Technical Report

Safety component

Digital Input card

Report No. TF93594T

Figure 1:   System overview

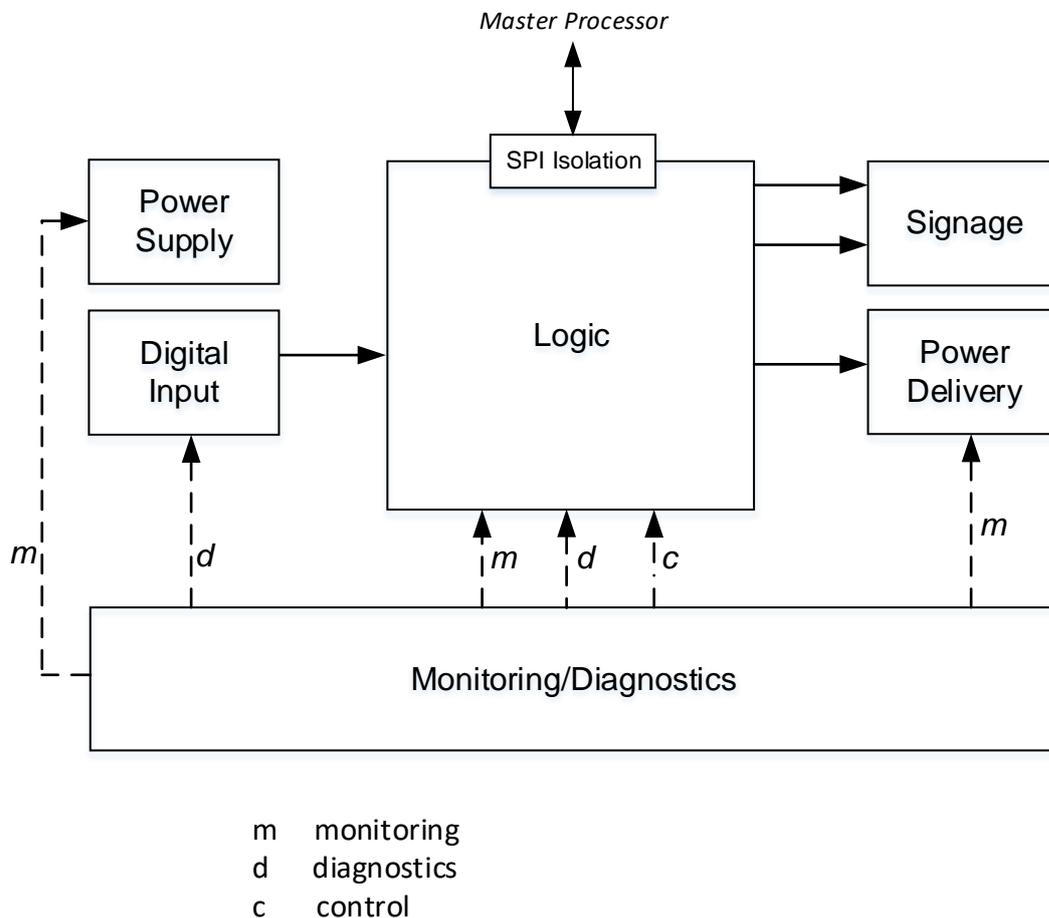
The Digital Input card hardware architecture consists mainly of a single channel structure with diagnostic for the logic and the in- and outputs components, see [D1].

The basic diagnostic principles are:

- Self tests including on-chip tests
- Window-Watchdog and independent shutdown path
- Suppression and control of under and overvoltage for all power supplies

The hardware architecture (1oo1D) is generally suitable for SIL2 / PLd / CAT2 . The architecture and the effectiveness of the selected diagnostic measures have to be verified during the project detailed phase by TÜV SÜD Rail GmbH.
